# United States Patent and Trademark Office

ATTORNEY DOCKET NO. FILING DATE FIRST NAMED INVENTOR CONFIRMATION NO. APPLICATION NO. 07/15/2003 Anand Huprikar 10/619,913 12163 7163 **EXAMINER** 28484 7590 10/07/2004 **BASF CORPORATION** NGUYEN, XUAN LAN T LEGAL DEPARTMENT **ART UNIT** PAPER NUMBER 1609 BIDDLE AVENUE WYANDOTTE, MI 48192 3683

#### **DETAILED ACTION**

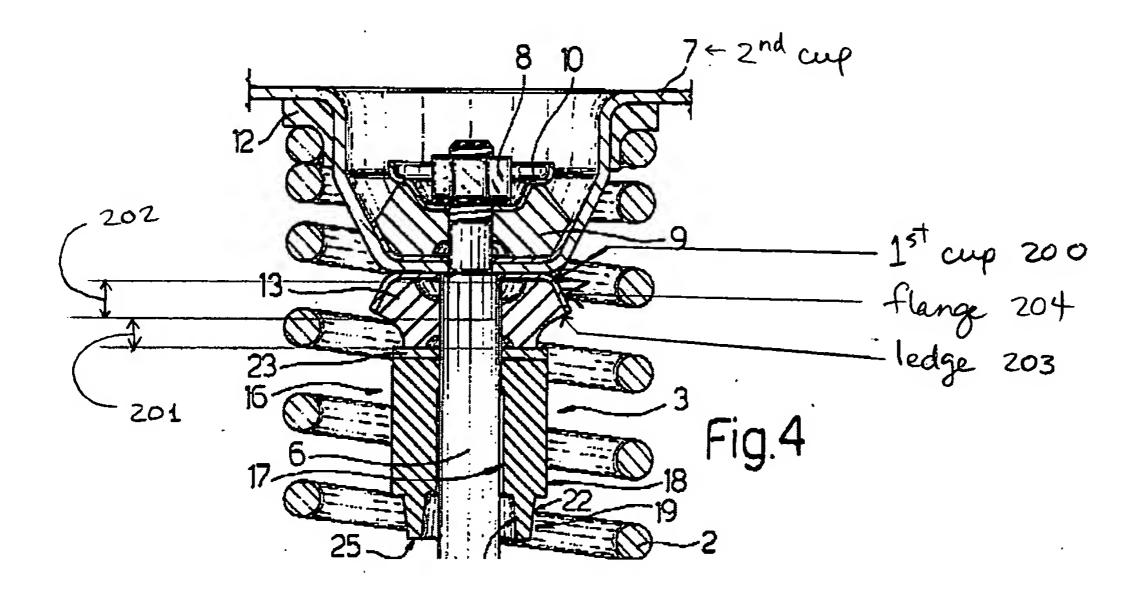
Re: claims 1 and 2, Tondato shows a mounting assembly for a wheel suspension system of a vehicle having a vehicle body, as in the present invention, said mounting assembly comprising: a support structure 200, 7, as marked on the illustration below, for the sake of convenience, the Examiner has assigned number 200 to one member of the support structure, having an aperture and adapted to be mounted to the vehicle body; a piston rod 6 at least partially disposed within said aperture and displaceable relative to said support structure along a line of travel; a plate 23 mounted to said piston rod, and moving relative to said support structure during said displacement of said piston rod 6; and an insulator 13 disposed between said support structure 200, 7 and said plate 23 with said insulator 13 substantially surrounding said piston rod and abutting said plate 23 for coupling said piston rod 6 to said support structure 200, 7; said insulator 13 having a first portion 201, as marked below with number 201, defining a first resistance for isolating said displacement of said piston rod and said plate during an application of a first force along said line of travel in a first direction, which at least partially compresses said first portion, and a second portion 202, as marked below with number 202, defining a second resistance with said second resistance being greater than said first resistance for controlling said displacement of said piston rod and said plate after said application of said first force and during an application of a second force along said line of travel in said first direction, wherein said second force is greater than said first force such that said first portion is compressed before the second portion is compressed. Note that first portion 101 is a thinner doughnut shape than second portion 202. Due to this structure, the first portion inherently would define a first

Re: claims 3 and 4, figure 4 shows that the first and second portions of the isolator are formed of the same homogenous material.

Re: claims 6 and 9-11, figure 4 shows the second portion has a greater width and greater circumference than those of the first portion thus forming a ledge 203, as marked above, wherein said ledge 203 is formed of a common homogenous material.

Re: claims 18 and 19, Tondato further shows a second insulator 9 mounted within the second cup 7 of the support structure 200, 7.

mounting assembly comprising: a support structure 200, 7, as marked on the illustration below, for the sake of convenience, the Examiner has assigned number 200 to one member of the support structure, having an aperture and adapted to be mounted to the vehicle body; a piston rod 6 at least partially disposed within said aperture and displaceable relative to said support structure along a line of travel; a plate 23 mounted to said piston rod, and moving relative to said support structure during said displacement of said piston rod 6; and an insulator 13 disposed between said support structure 200, 7 and said plate 23 for coupling said piston rod 6 to said support structure 200, 7; said insulator 13 having a first portion 201, as marked below with number 201, defining a first resistance for isolating said displacement of said piston rod and said plate during an application of a first force along said line of travel in a first direction, which at least partially compresses said first portion, and a second portion 202, as marked below with number 202, defining a second resistance with said second resistance being greater than said first resistance for controlling said displacement of said piston rod and said plate after said application of said first force and during an application of a second force along said line of travel in said first direction, wherein said second force is greater than said first force such that said first portion is compressed before the second portion is compressed, a jounce bumper 3 disposed about said piston rod 6 and mounted to said plate 23 on an opposite side from said insulator 13 for translating movement of the wheel suspension system during application of said second force. Note that first portion 101 is a thinner doughnut shape than second portion 202. Due to this structure, the first portion inherently would define a first resistance that is

Re: claim 34, Tondato shows first portion 201 has a first maximum width smaller than a second maximum width of said second portion 202 to form ledge 203.

Re: claims 38 and 39, Tondato shows first cup 200 having a flange 204, said first cup 200 surrounds first portion 201; and said ledge 203 engages and compressed against said flange 204 to transmit loads to said support structure, as claimed.

Re: claims 40-42, Tondato shows a mounting assembly for a wheel suspension system of a vehicle having a vehicle body, as in the present invention, said mounting assembly comprising: a support structure 200, 7, as marked on the illustration below, for the sake of convenience, the Examiner has assigned number 200 to one member of the support structure, having an aperture and adapted to be mounted to the vehicle body; a piston rod 6 at least partially disposed within said aperture and displaceable relative to said support structure along a line of travel; a plate 23 mounted to said piston rod, and moving relative to said support structure during said displacement of said piston rod 6; and an insulator 13 disposed between said support structure 200, 7 and said plate 23 for coupling said piston rod 6 to said support structure 200, 7; said insulator 13 having a first portion 201, as marked below with number 201, defining a first resistance for isolating said displacement of said piston rod and said plate during an application of a first force along said line of travel in a first direction, which at least partially compresses said first portion, and a second portion 202, as marked below with number 202, defining

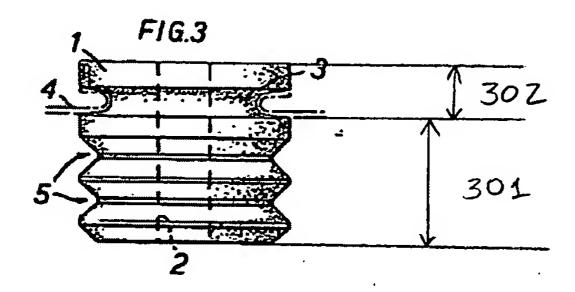
Re: claims 7, 8, 35, 46 and 47, Tondato's mounting assembly and isolation apparatus, as rejected above, lack the height for the first portion 201 of the insulator to be higher and to be three times as high as the height of the second portion 202.

Nagashima teaches in figure 3 an insulator with the first portion 301, as marked below, to be three times as high as the second portion 302, as marked below, in order to

further providing gradual increase in the level of dampening. It would have been obvious to one of ordinary skill in the art at the time the invention was made to have modified Tondato's mounting assembly and insulator to include an insulator as taught by Nagashima wherein the height of the first portion is three times as high as the second portion in order to further provide gradual increase in the level of dampening to result in a softer ride for the passengers.
